Addendum No. 1
October 21, 2022

**Biotech/Life Sciences Deionized Water Piping
Upgrades**
Washington State University
Pullman, WA

Project No. 1816-2022
Washington State University
Facilities Services, Capital

S203R

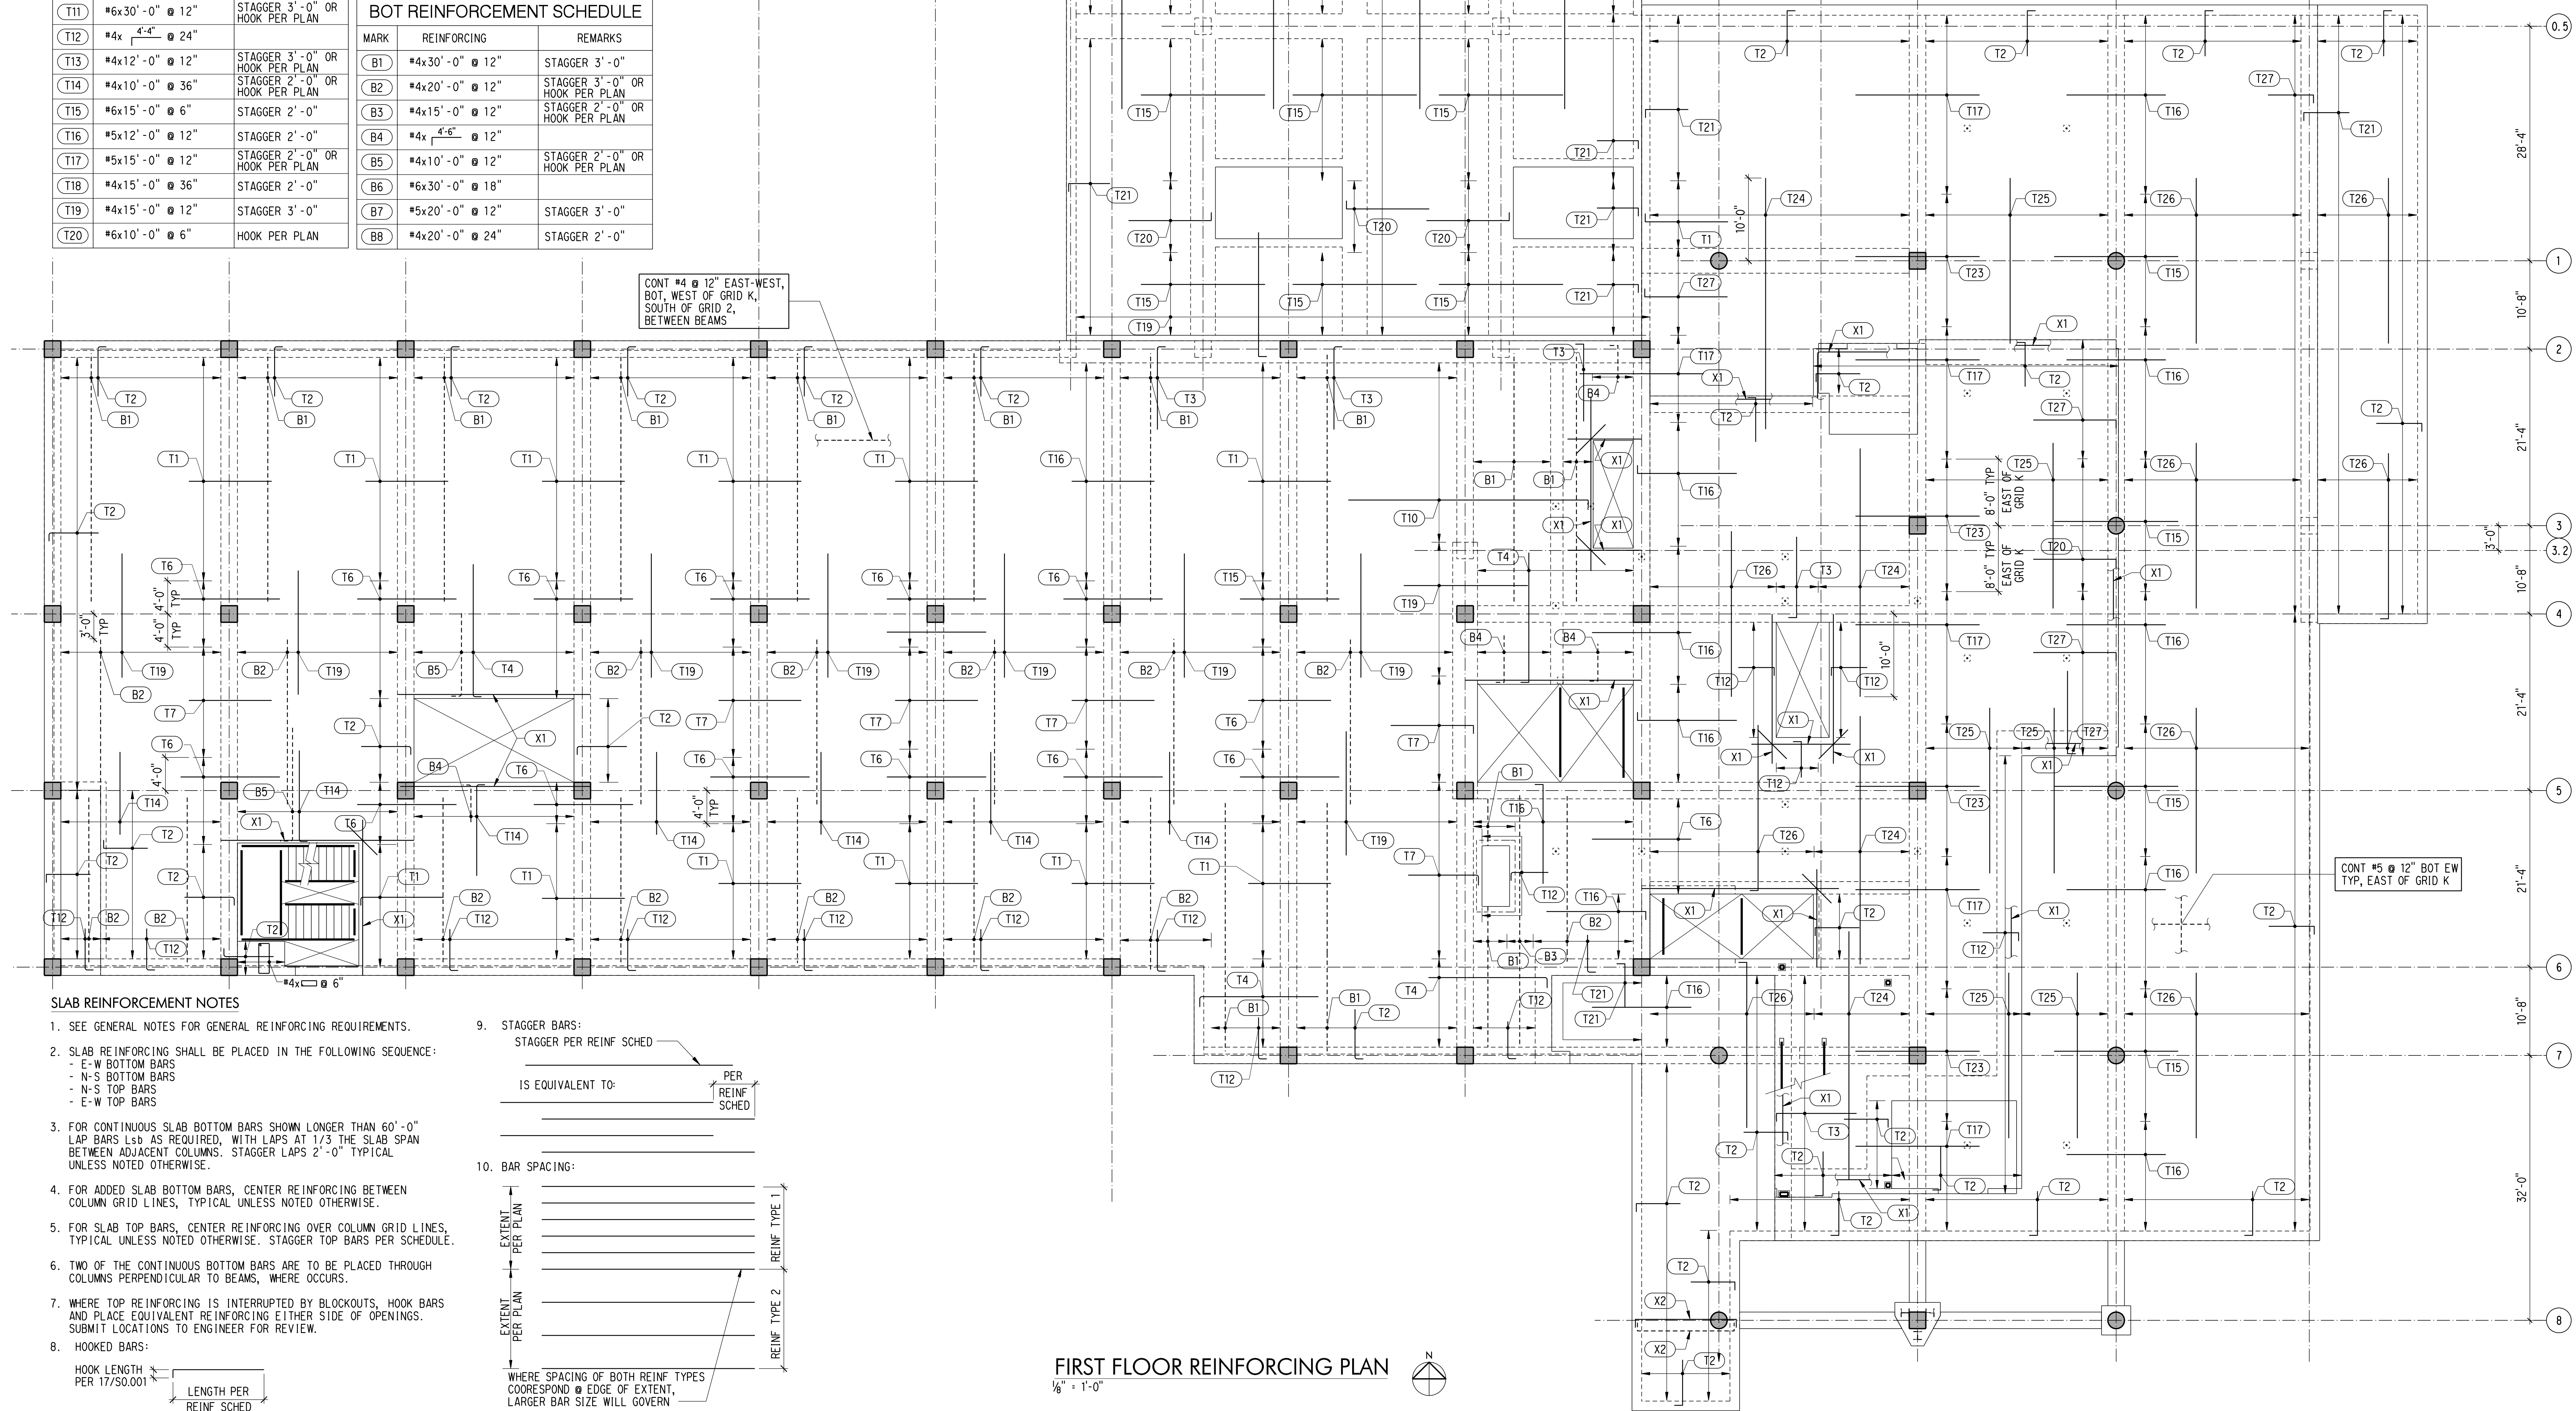
DWG 1-1. Drawing S203R – As-Build First Floor Reinforcing Plan

- Item 1. As-built of the original construction showing rebar locations.

1. *Can we abandon the pipes that are not accessible? WSU Response-Yes*
2. *Can the system be shutdown during construction duration? WSU Response-No*
3. *The drawings say to core drill through the floor. Are there asbuilts showing the location of the rebar in the floor slab or do we xray the area we are core drilling? WSU Response-we will review the asbuilts and let you know if the rebar is shown. If there's no rebar location shown on the asbuilts you should plan on x-raying the floor slab.*
